Solicitation No. EQ734-181253/A

Project No. R. 074854.001 New Gates and Barriers at Warkworth Institution, Warkworth, ON

Questions and Answers:

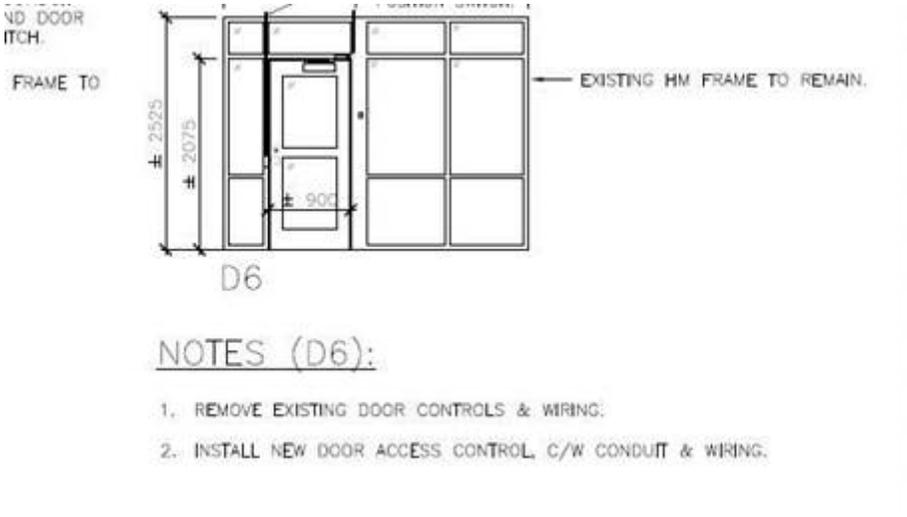
In the drawings for the new gates there are notes on drawing CSC 460-3408 for

But no spec listed... is this part of the contract..?

If so – please provide scope or further information.

Response 1: The query refers to Detail 1 on Drawing #E5. This work is in the contract. Further details are provided on Detail 2 on drawing A2, on Drawing A1, in the Detention Hardware specification section (11 19 12) and the Detention Hardware Schedule (section 11 19 12.01). To clarify "Access Control" refers to the electro-mechanical locks detailed in paragraph 2.5 in spec section 11 19 12, along with associated items such as door position indicator switch and control device specified in electrical spec section 26 29 03.
